***MODIFICATION REQUEST:
Sydney Metro City and Southwest –
Chatswood to Sydenham***

***Sydenham Station and Sydney Metro Train Facility
South (MOD 4)***

Environmental Assessment Report
Section 115ZI of the
Environmental Planning and Assessment Act 1979

December 2017

Figure 7: Proposed bus and cycling routes (Source: Modification Report)

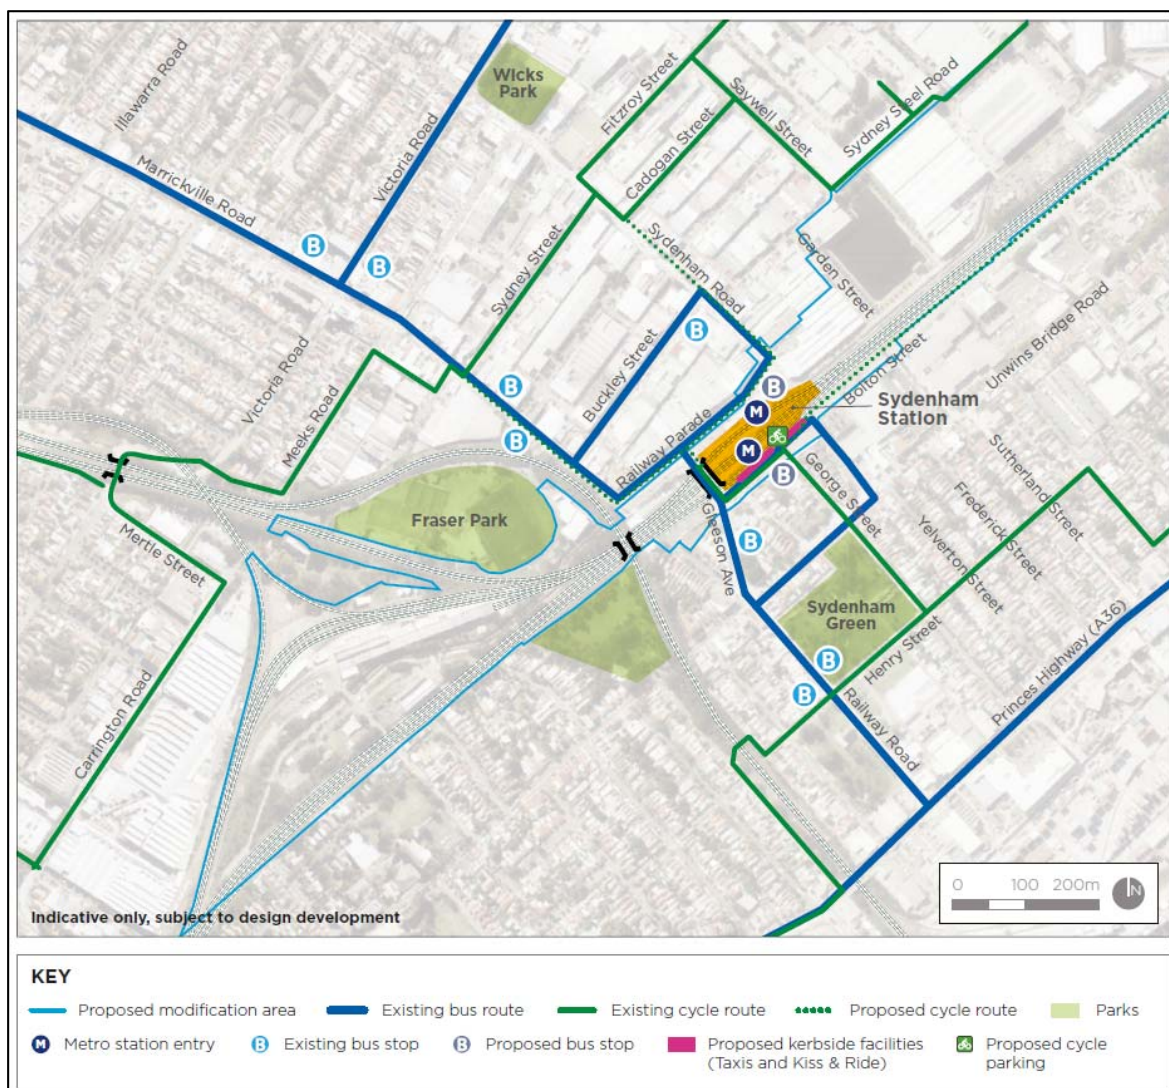
Council raised concerns regarding the proposed on-road cycle connection (the dotted green line in **Figure 7**) and proposed an alternative connection from Sydenham Station to the ATC via a dedicated pedestrian/cyclist path within and to the south of Fraser Park to provide the desired level of connectivity outlined in the *Revised Draft Sydenham to Bankstown Urban Corridor Strategy* (the Strategy).

The Proponent noted that the Strategy depicts the Greenway South West connecting Sydenham and Marrickville stations via a cycle route consistent with that identified by council and committed to further explore opportunities to integrate with other planned infrastructure with Council to facilitate the staged completion of the ATC. Council maintains that the proposed on-road cycle connection is not acceptable and advised that the stated commitments do not adequately address its concerns.

The Department notes that the Strategy identifies an off-road cycle route around Fraser Park as part of the Greenway South West but that design and funding of this requires finalisation. Therefore, the proposed on-road route from Sydenham Station provides a suitable interim connection to existing cycle routes.

Although the Department supports the Proponent's proposed on-road cycle connection and commitment to work with Council to facilitate the completion of the ATC, an additional condition is recommended requiring the Proponent to investigate opportunities for a dedicated cycle connection between Sydenham and Marrickville stations and not preclude future delivery of any identified connection in developing the relevant IAP (condition E92) and SDPP (condition E101). The investigation must be undertaken in consultation with the TTLG, which includes Council representation.

Figure 8: RING noise exceedance receivers (Source: Modification Report)

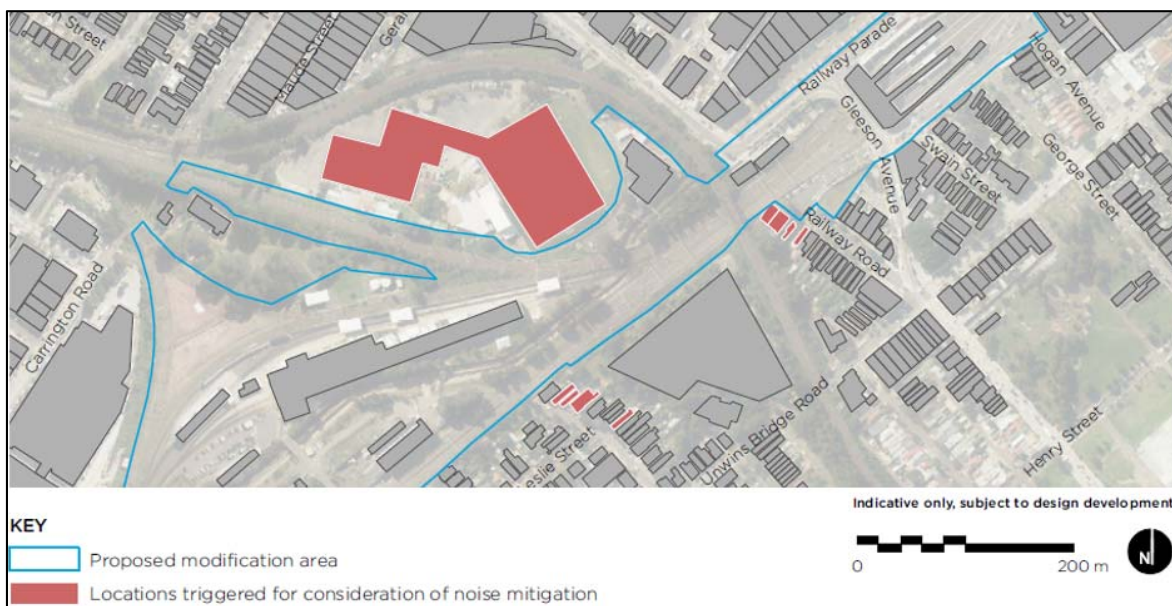
Exceedances of the operational NML are anticipated at nine residential receivers and Fraser Park shown in **Figure 8**. The Proponent proposed to address this impact using noise barriers in the locations shown in **Figure 9**. The requirement, extent and design of these barriers would be further considered during detailed design.

The Department acknowledges that construction and operation of the proposed modification would generate noise impacts and that these impacts would be greater and for a longer duration than those identified for the approved Project. However, the Department is satisfied that the comprehensive suite of noise management measures included in the existing approval would provide an appropriate approach to noise and vibration management. These include:

Figure 10: Proposed flood levels change (one per cent AEP plus ten per cent for climate change) (Source: RtS)

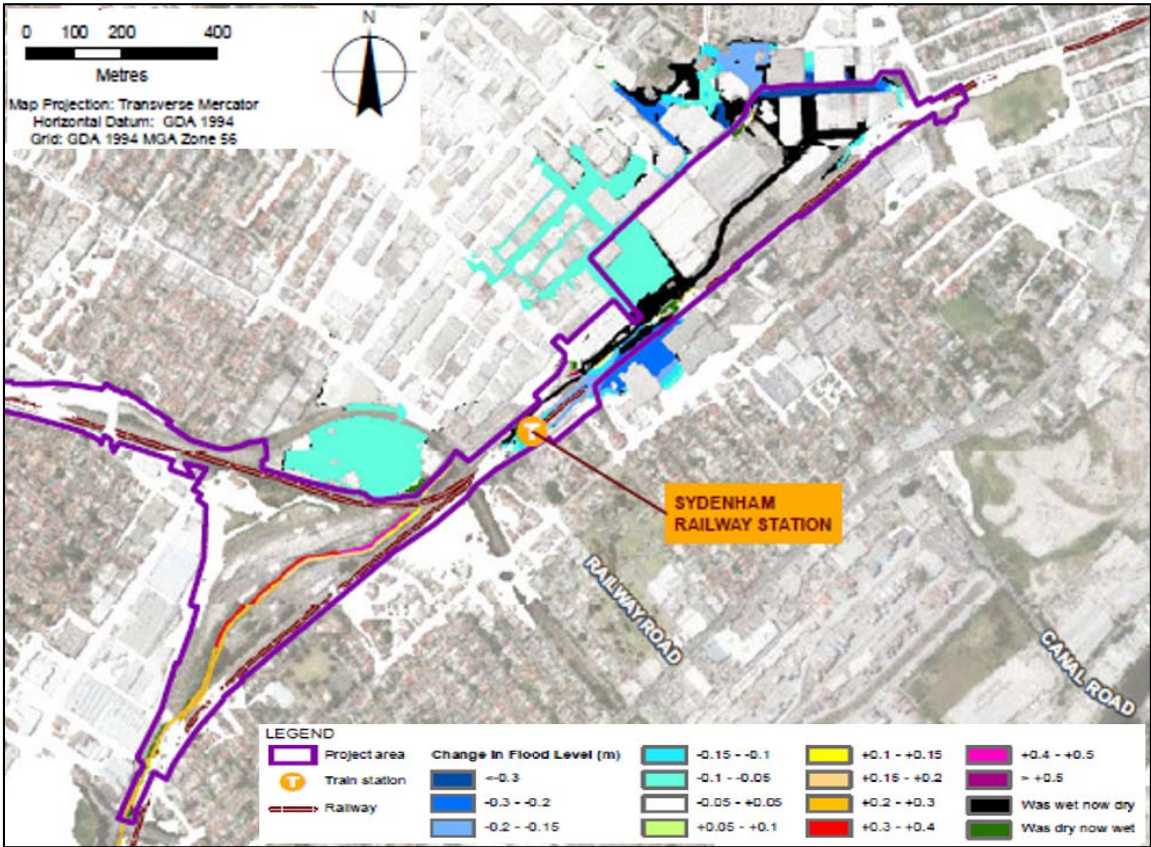
The proposed modification would result in changes to the existing stormwater drainage network (as detailed in Section 2.3) generally resulting in reduced flood impacts compared to the approved Project, as shown in **Figure 10** and **Figure 11**. However, the aqueduct piers and access ramp would decrease the available storage capacity of the Sydenham Pit; however, the pump out rate would be increased to address this.

Council, Sydney Water, OEH and public submissions raised concerns regarding flooding and hydrology. In particular, Council identified that the proposed works:

Condition E8 requires mitigation measures to maintain or improve flood characteristics identified in the Preferred Infrastructure Report for the approved Project to be incorporated into the delivered project. This condition will be amended to ensure that these measures are also applied to the proposed modification. The incorporation of these measures must be reviewed and endorsed in consultation with affected landowners, businesses and Council.

The Department is satisfied that the modification would have negligible impact relative to the existing flood hazard in the one per cent AEP and PMF scenarios, and that the revised mitigations measures, in conjunction with existing conditions, will adequately address potential flood impacts.

Figure 12: Proposed property acquisition (Source: Modification Report)

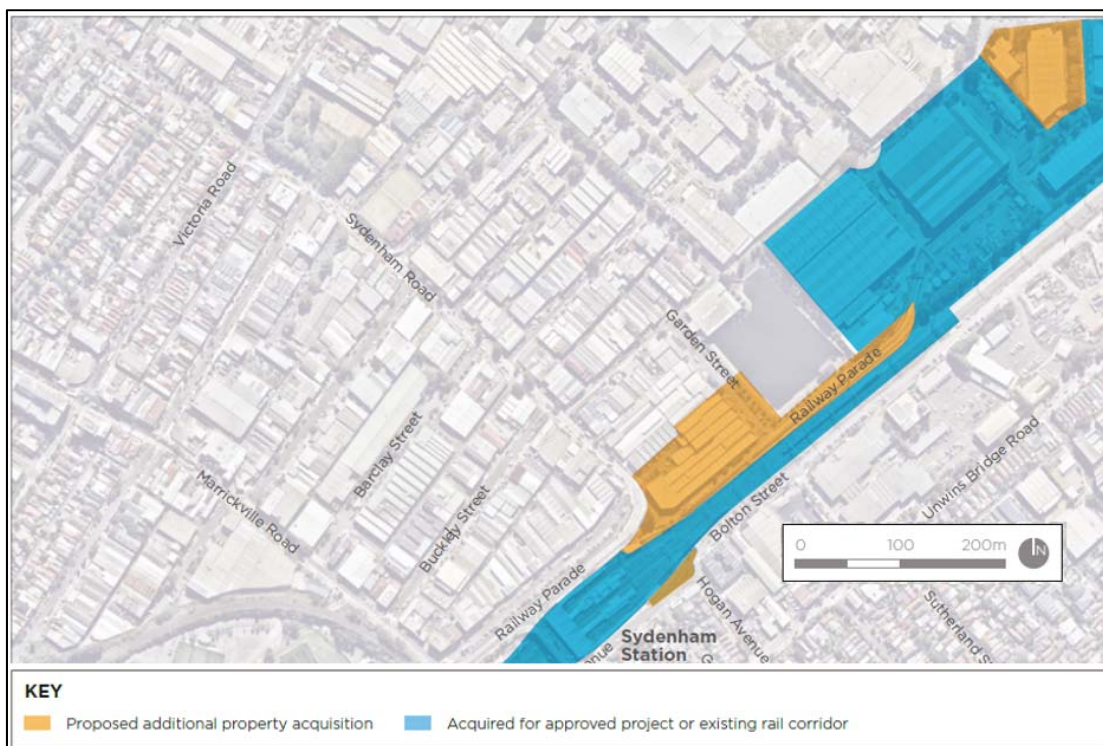
Council raised concerns regarding the loss of land currently used for employment, industrial and creative purposes because of the proposed land acquisitions and potential future expansion of the SMTFS. To partially offset any such loss, Council requested that the Proponent be required to provide a space above the SMTFS for creative industries.

The Department acknowledges Council's concerns regarding the loss of employment and industrial land, which are increasingly under threat and requested that the Proponent be required to provide replacement employment land and creative space above the SMTFS. The SMTFS would be constructed to enable future development above it. The use of that space will be subject to local planning regulations and any such development would be subject to a separate approval process.
